Architectural Review Board Staff Report

Project Type: Site Development Section Plan

Meeting Date: November 14, 2013

Description: **Kemp Auto Museum (Chesterfield Covenant Group) SDSP:** A Site Development Section Plan, Landscape Plan, Lighting Plan, Architectural Elevations and Architect's Statement of Design for a 0.709 acre tract of land zoned "PC" Planned Commercial District on the north side of Chesterfield Airport Rd., approximately 1,000 feet east of Chesterfield Commons Dr. (17T230189).

Figure 1: Site Photo

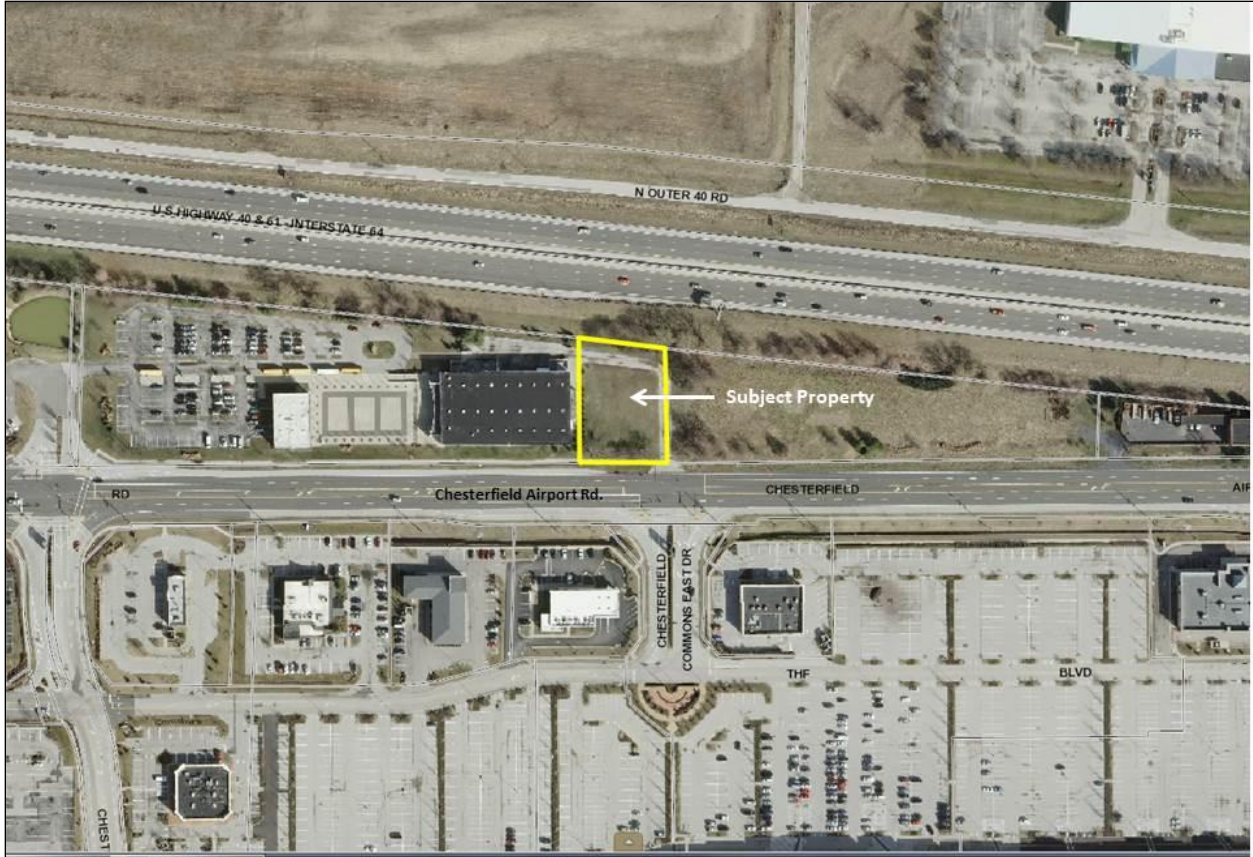
The proposed structure is to be situated along the frontage of Chesterfield Airport Road with accessory parking to be placed within the rear of the lot (I-64 frontage). With the placement of the structure along the frontage of Chesterfield Airport Road, the proposed building would be consistent with the adjacent Kemp Auto Museum to the west which is similarly situated (see figure 1 on page 2).
